Service Bulletin

SUBJECT: Service Update for Inventory Vehicles Only
Transmission Snap Ring Misalignment
Expires September 30, 2014

MODELS: 2013 Buick Regal, LaCrosse
2013 Chevrolet Malibu
Equipped with 6T40 Automatic Transmission (MHH)

Subject: 13282A – Service Update Bulletin
Transmission Snap Ring Misalignment
Revised Warranty Transaction Information

3613040

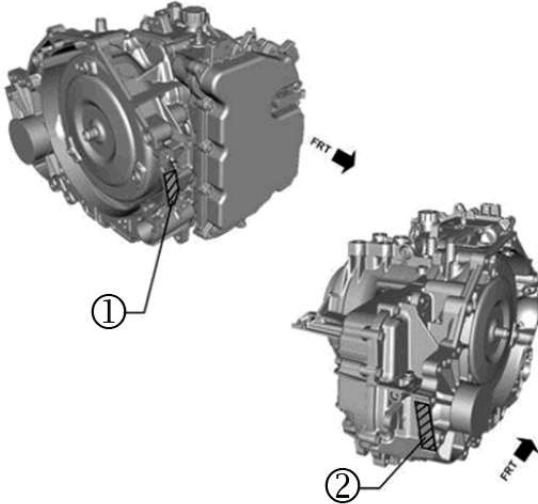
Note: A VIN derivative is required to be permanently engraved on the new transmission prior to installation. Refer to the illustration above for VIN engraving location points. Select one of the locations to engrave the required characters. VIN derivatives must be formatted as indicated below (# = last eight characters of the VIN).

Buick Regal and LaCrosse: 1J*4#####B

Chevrolet Malibu: 1J*1#####B
